266 – 270 Pulteney Street, Adelaide

020/A066/19

OVERVIEW

ASSESSMENT REPORT

Figure 4 - North and South Facade

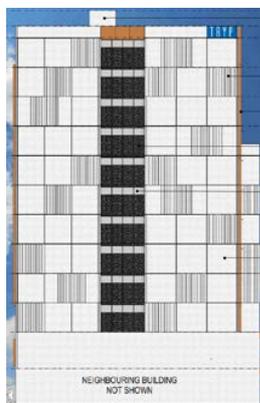
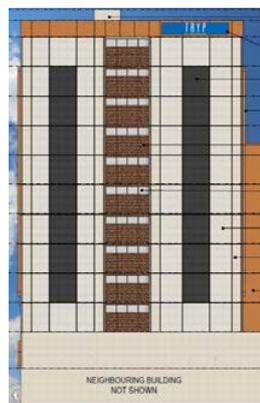
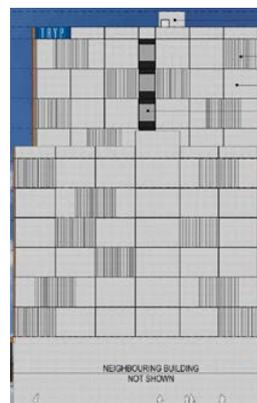
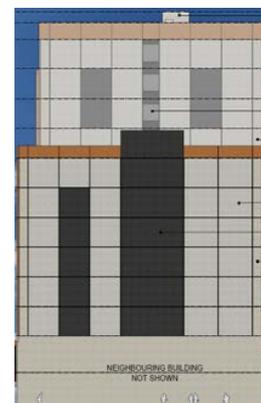
The Government Architect initially raised concerns regarding the proposed painted northern and southern elevations due to the limited durability and longevity of this finish. The applicant acknowledged these concerns and provided a revised finish which utilises Nawkaw, additional articulation was also expressed on the north and south facades with the inclusion of 30-50mm recessions.

The northern and southern façade previously utilised vertical grooves cut into the precast concrete panels to break up the expansive concrete façade and to provide some visual interest. The revised façade incorporates the removal of the vertical grooves and initially proposed a painted finish to reflect the vertical proportions of the proposed development. A painted finish has also been applied to the lift shaft and stair core on the southern elevation to further emphasis the height and proportions of the built form. The applicant also choose to provide a hierarchy to the elevations, with the off-form precast finish to both Pulteney and Gunson Street, returning one panel to the north and south elevation. This design detail is considered subtle and questionable whether it provides a hierarchy in elevations.

The applicant acknowledged these concerns and provided further revised plans which now utilises Nawkaw on the northern and southern façade to ensure greater durability and integral finish. Additional articulation of the darker charcoal coloured panels is now expressed through the inclusion of recessions of 30 to 50mm, which should provide a level of articulation and design detail.

To assist in the reflection of the design intent and create a building in the round, the darker charcoal coloured panels on the north and southern facades will be slightly recessed (30-50mm) to create a further link to the feature darker sections on the west and east facades and the change in depth associated with the wraps on those facades.

WEST ELEVATION (PULTENEY St)

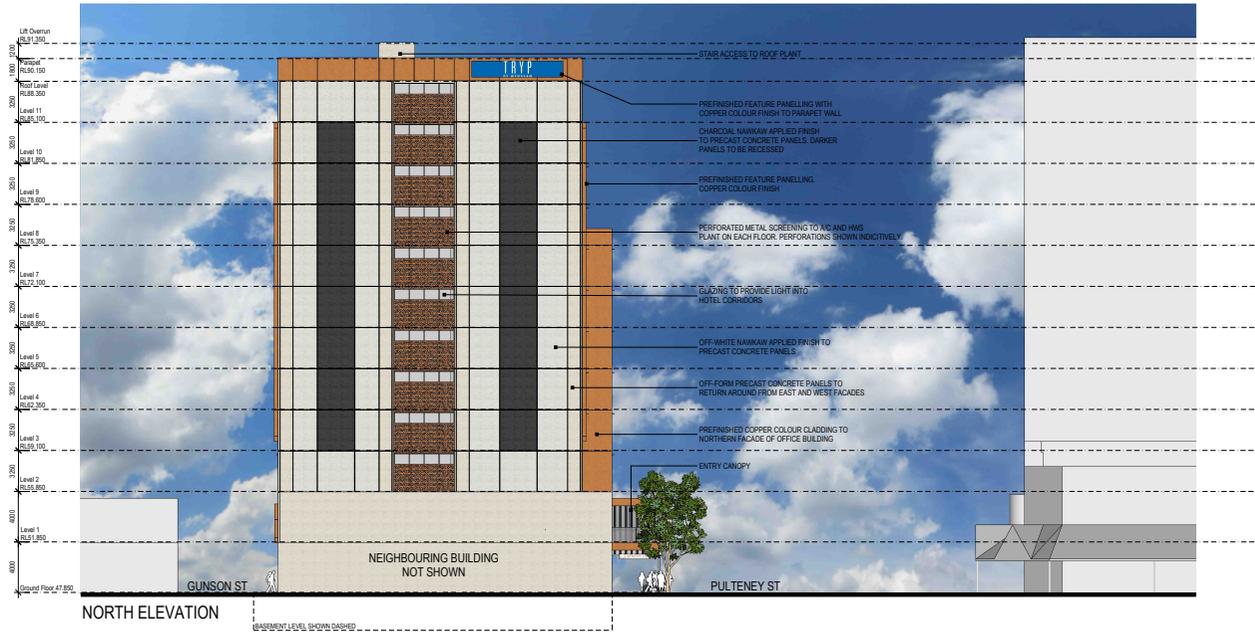
The applicant provided revised plans of the proposal which reduces the three asymmetrical protruding elements on the hotel's western and eastern façade to a singular central protrusion. The applicant noted that the central protrusion now aligns with the precast joint and is treated in the same materials and colour as the office building element. The canopy located above the Hotel's main entrance has also been revised to ensure it symmetrically aligns with the singular width of the central protrusion.

The copper Vitra Panel previously proposed on the southern edge of the western façade of the hotel has been removed, in an attempt to provide a simpler façade with precast panels now defining the edges of the building. The copper Vitra Panel has also been added to the northern edge of the office building element, which is supported by the Government Architect. The copper banding element on the western parapet is now proposed across all the elevations, which provides greater consistency in architectural expression.

We stress the importance of the protruding elements linking the components of this building, and with the introduction of cladding to the northern edge of the office building, the architectural approach of protruding boxes in the copper VitraPanel is consistent to each of the building masses. They both provide layers to the facades forward of the main east and west facades (composed of the precast elements).

REV 'C'
SK.09
Job No. 6873-1
May 31, 2019

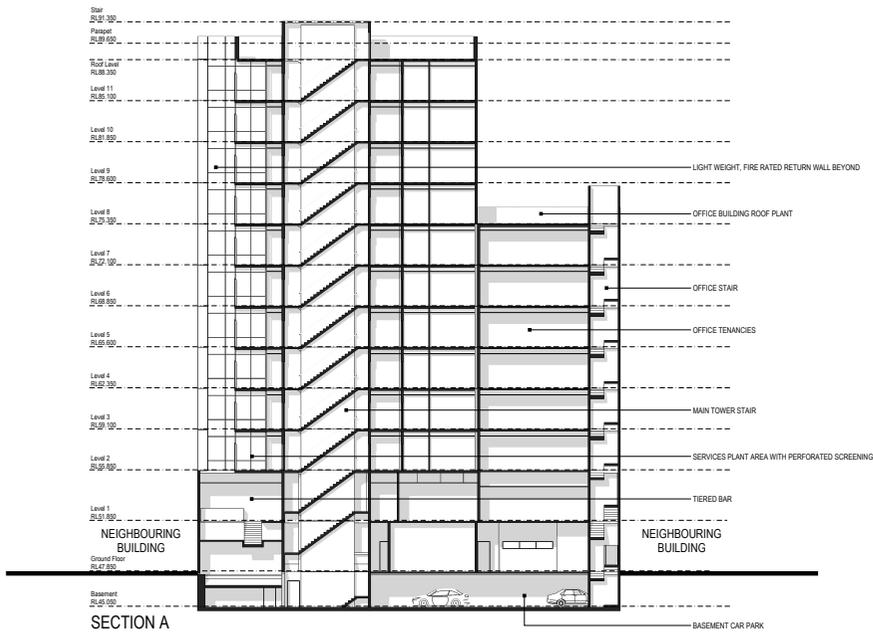
- **Concerns about the use of a paint/applied finish for a building of this scale.**
Rather than a paint finish, the design team is proposing to use a product called Nawkaw to stain the precast concrete panels on the north and south facades to provide the two different colours. Nawkaw offer a 30-year guarantee on their product during which time very minimal maintenance is required.
The use of the Nawkaw product allows the design to provide subtle articulation to the north and south facades and reflect the design intention more prominent on the west and east façades, which we believe is a practical way to achieve "building in the round" when walls are on the boundary.
These changes can be seen on the amended elevations SK.08 and SK.09 as well as the amended 3D views.

To provide some hierarchy to the elevations, the off-form finish to both Pulteney and Gunson St will return one panel on to the north and south elevation. We believe this contributes to making the building more unified but also indicates that the main facades are facing Pulteney and Gunson Streets.

REV 'B'
 SK.10
 Job No. 6873-1
 May 31, 2019

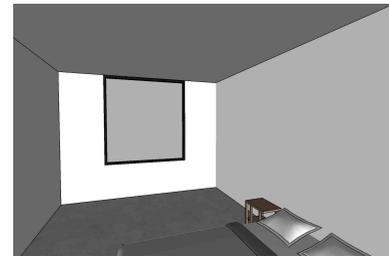
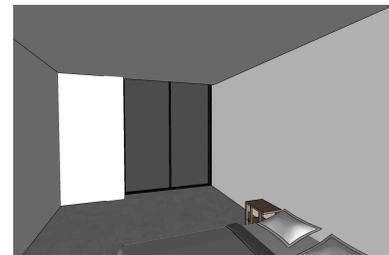
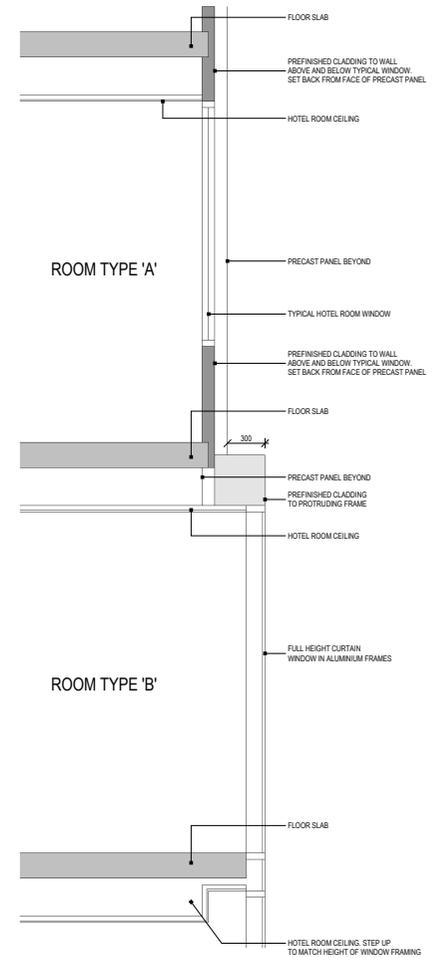
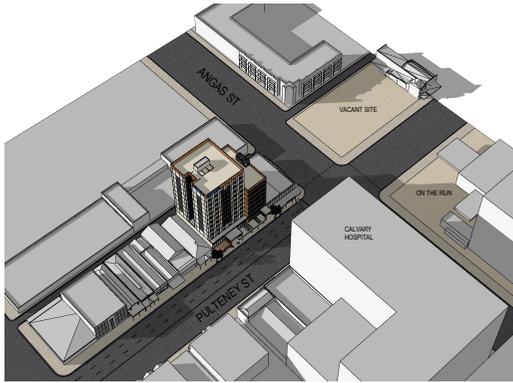
- **Concerns that the protruding frame does not provide diversity in hotel rooms.**

In addition to the important role the protruding frame plays to the external elevation, it allows diversity within the hotel room configuration. On the attached amended drawing SK.10 Section A and B, we have provided simple sections and 3D views highlighting the differences in the two room types and indicating the glazing within the frame on the west elevation will be flush with the protruding frame. This might not have read correctly in our 3d model and so is clarified here.

Rooms within the protruding frame are slightly longer and have full height off centre darker curtain-window glazing. It is the intention that these rooms could be fitted out differently internally as well to provide additional diversity.
